ROCKFORD BOARD OF EDUCATION
INVITATION FOR BID ON SUPPLIES, MATERIALS, EQUIPMENT OR SERVICES
FOR SCHOOL DISTRICT NO. 205
ROCKFORD, ILLINOIS

RFQ No. **16-22 Riverdahl Elementary School Additions**

DATE: **Thursday, January 7, 2016**

RE: **ADDENDUM NO. 1**

1 LEVEL 00 ARCHITECTURAL DEMOLITION PLAN - AREA D & E

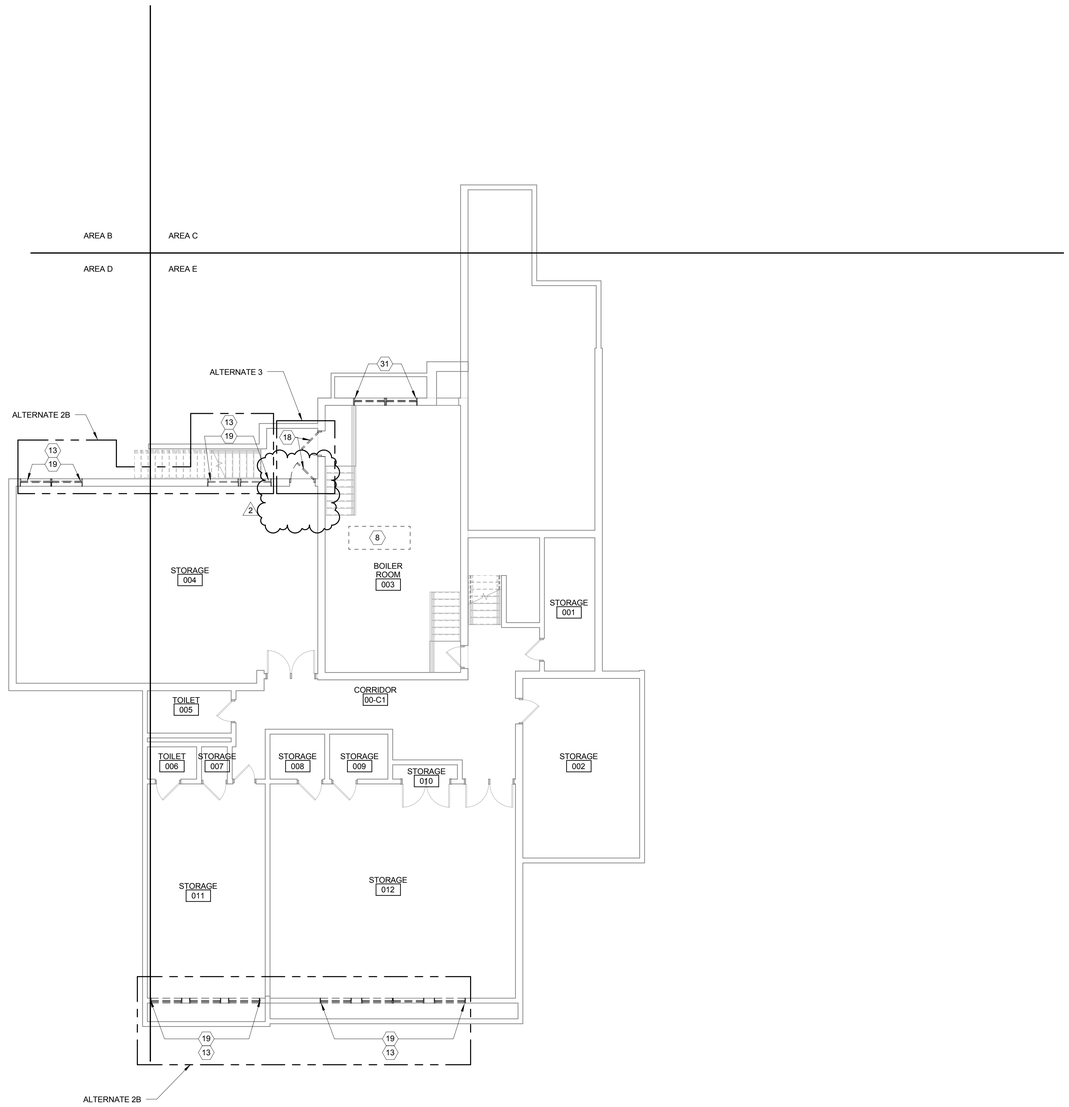
4. D0100.DE – LEVEL 00 ARCHITECTURAL DEMOLITION PLAN – AREA D & E

1 LEVEL 01 ARCHITECTURAL DEMOLITION PLAN -AREA C

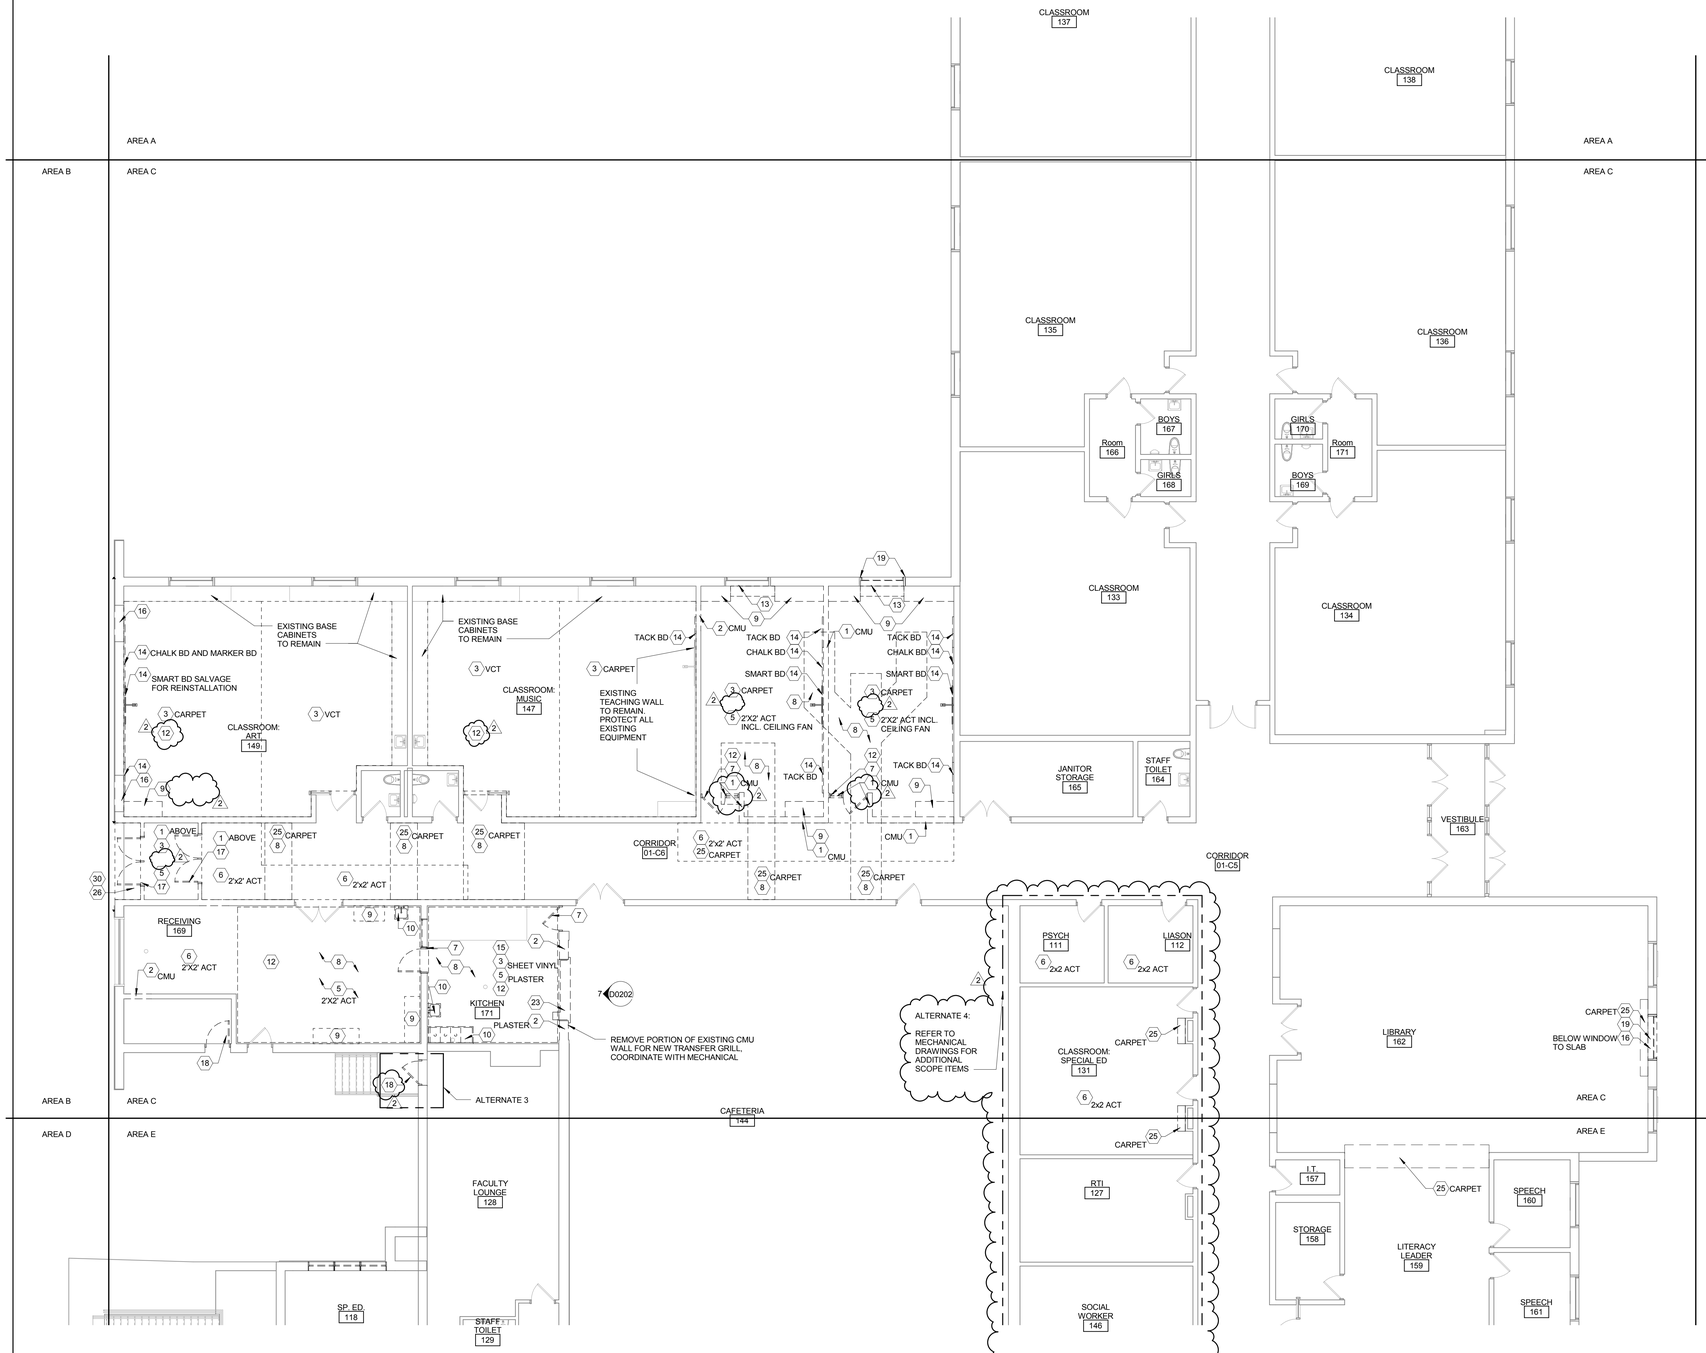
5. D0201.C– LEVEL 01 ARCHITECTURAL DEMOLITION PLAN – AREA C

B. Added keynote tag "12" to Classroom: Art 149 and Classroom: Music 147.

D. Removed keynote tag "17" and added keynote tag "18" to exterior door being removed at room Faculty Lounge 128

E. Added ALTERNATE 4 area and scope to rooms 146, 127, 131, 111, 112

1 AREA E ROOFPLAN DEMO
1/8" = 1'-0"

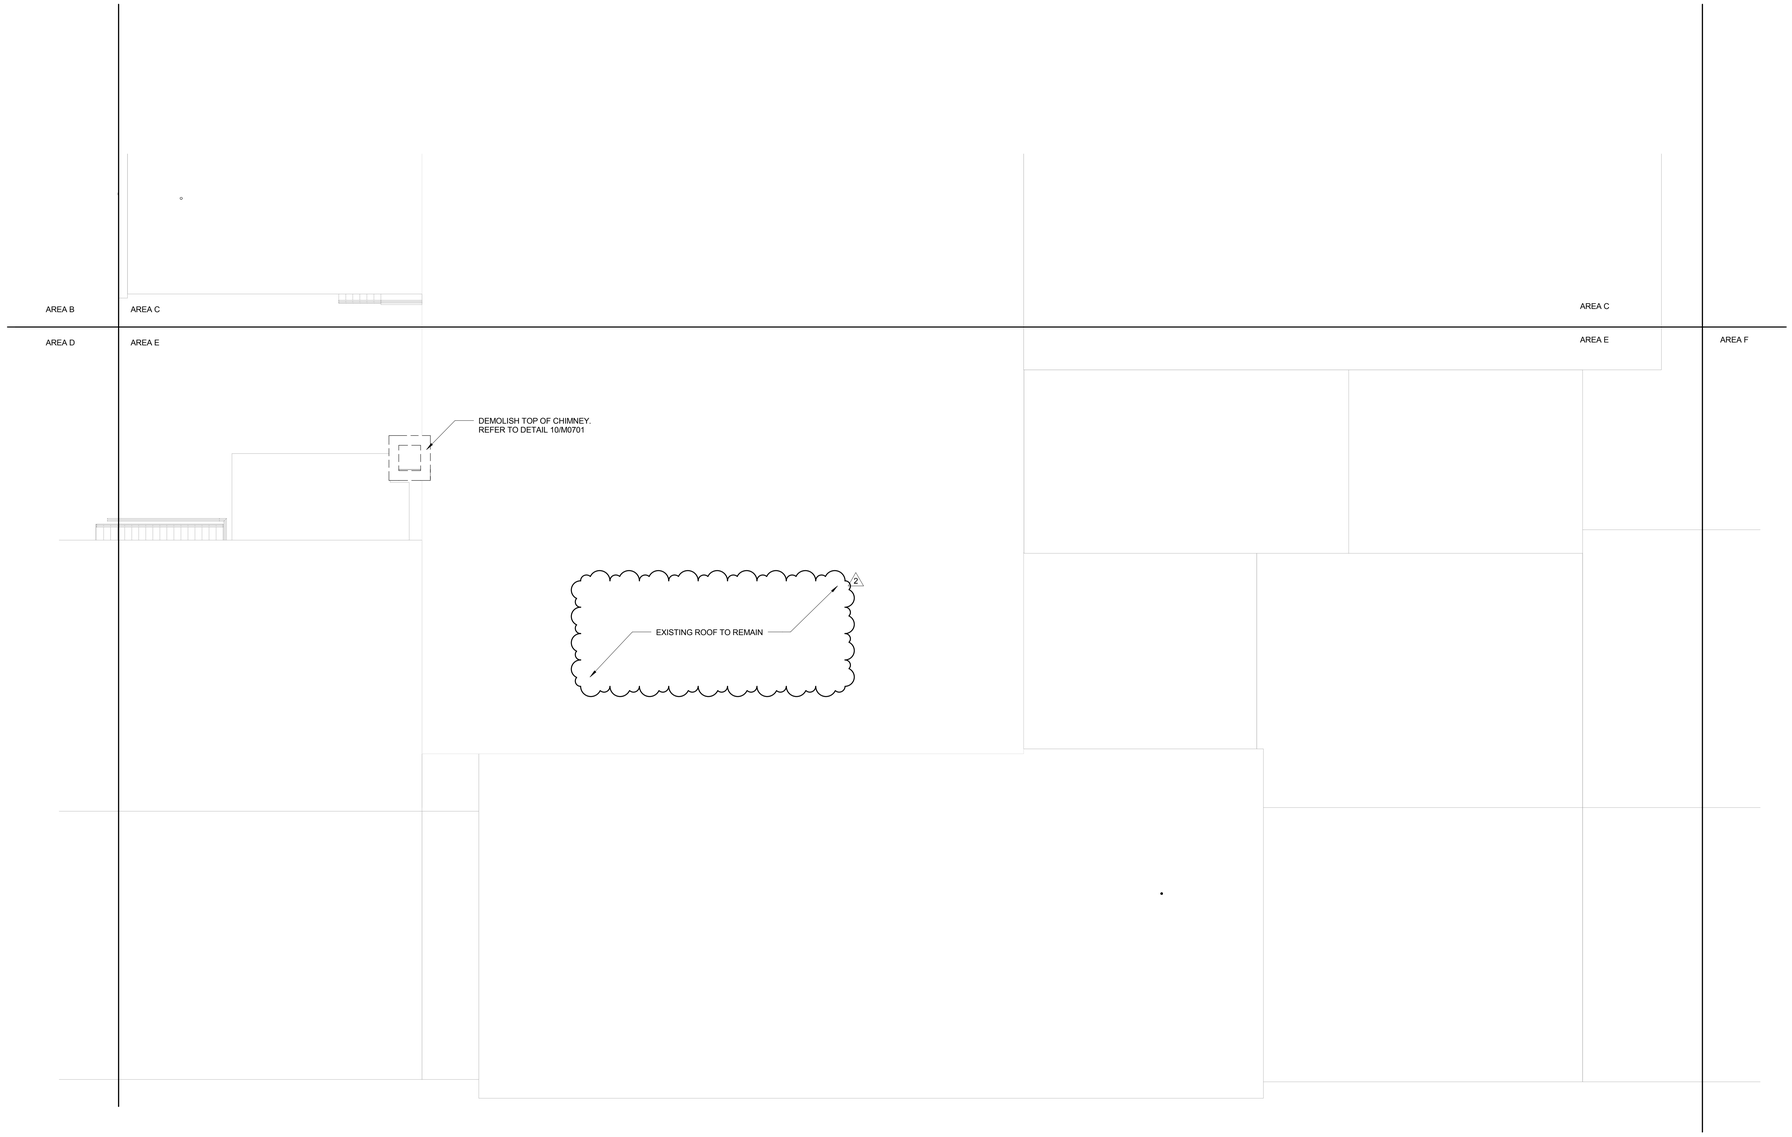
8. D0203.E – ROOF PLAN DEMOLITION PLAN – AREA E

A. Cleaned up the drawing background. Added a note "EXISTING ROOF TO REMAIN"

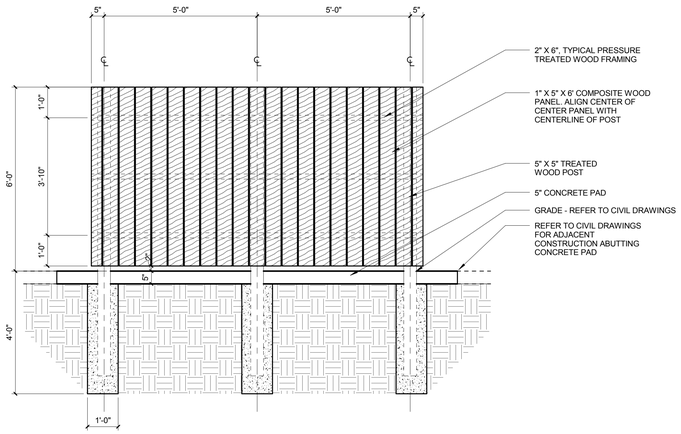
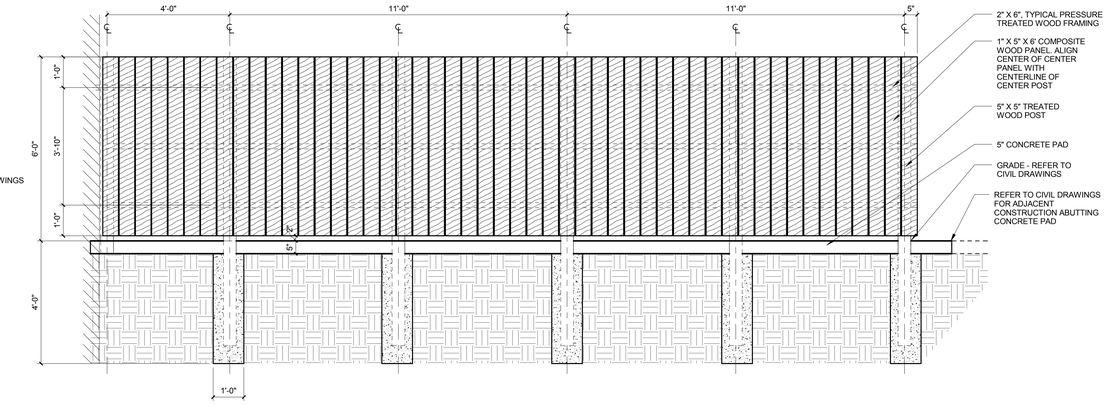
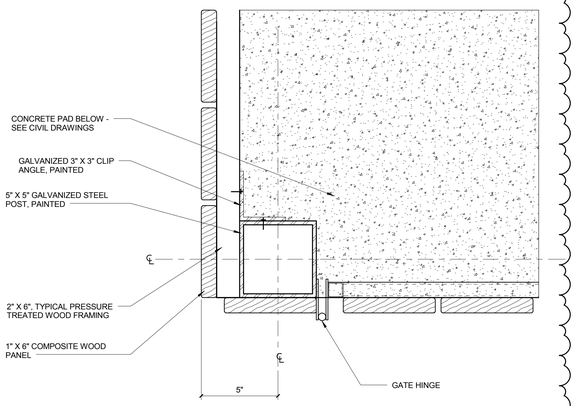
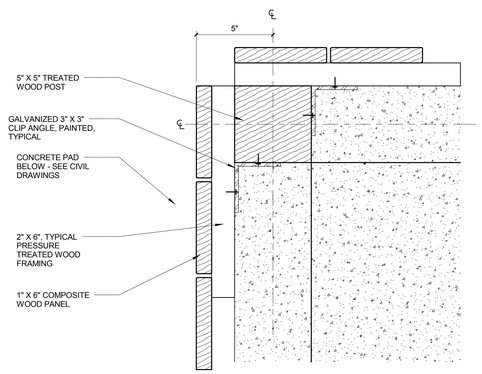
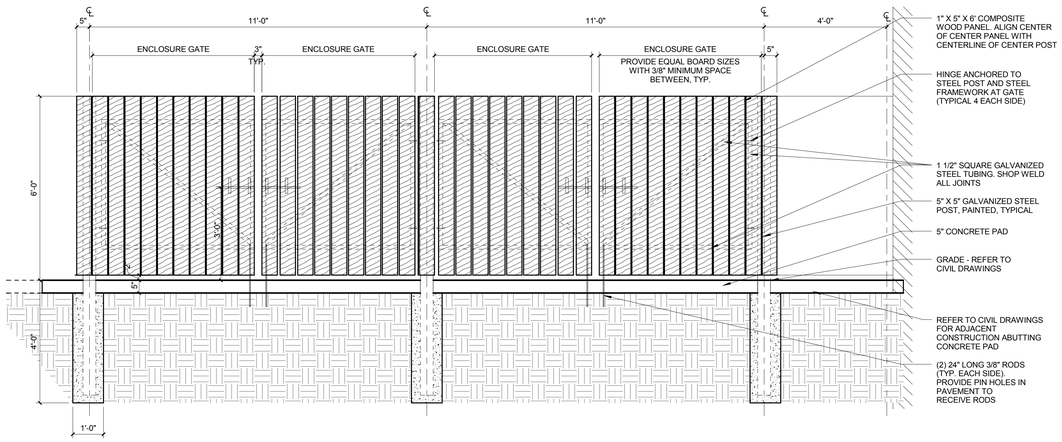
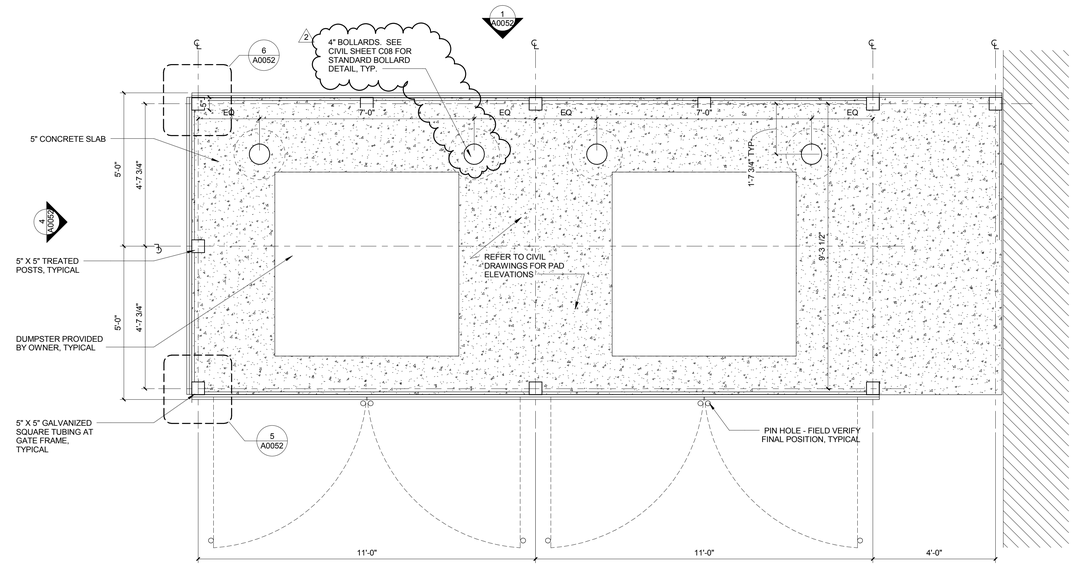
A. Rotated Detail 5 and Detail 6 to align with callouts on detail 3

B. Added a note to Trash Enclosure Plan: “4” BOLLARDS. SEE CIVIL SHEET C08 FOR STANDARD BOLLARD DETAILS, TYP.”

1 LEVEL 00 FLOOR PLAN - AREA D & E
1/8" = 1'-0"

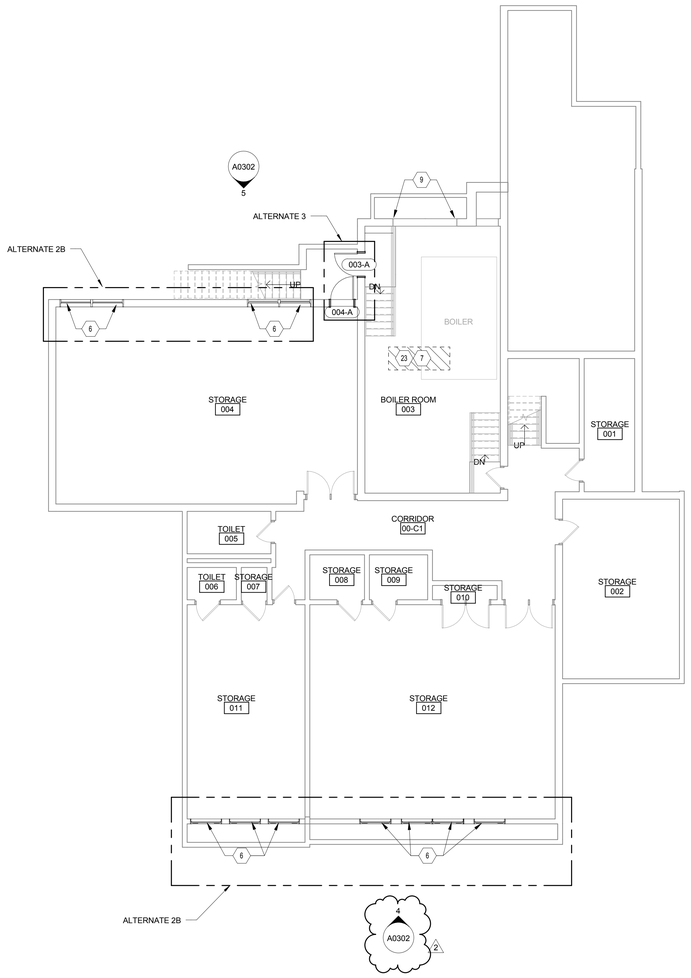
26. A0100.DE – LEVEL 00 FLOOR PLAN – AREA D & E

A. Added elevation tag 4/A0302 outside of Storage room 011 and 012

1 LEVEL 01 FLOOR PLAN - AREA B
1/8" = 1'-0"

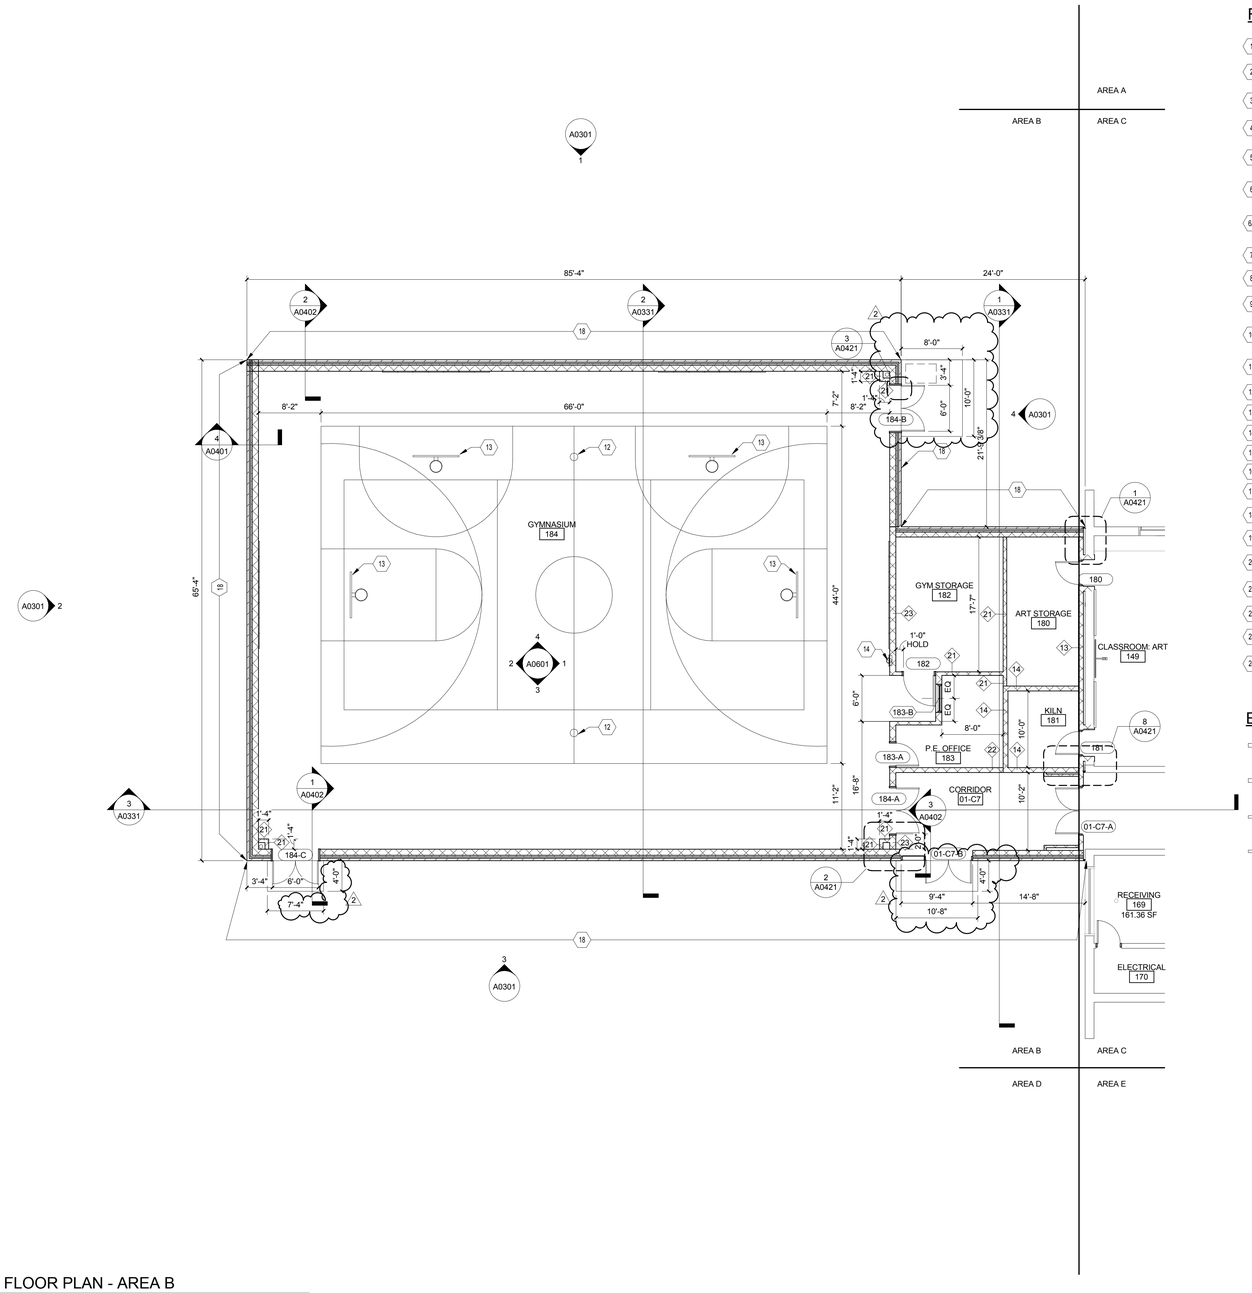
27. A0101.B – LEVEL 01 FLOOR PLAN – AREA B

A. Remove keynote 19 and square depicting knox box.

B. Revised Concrete Stoop sizes at doors
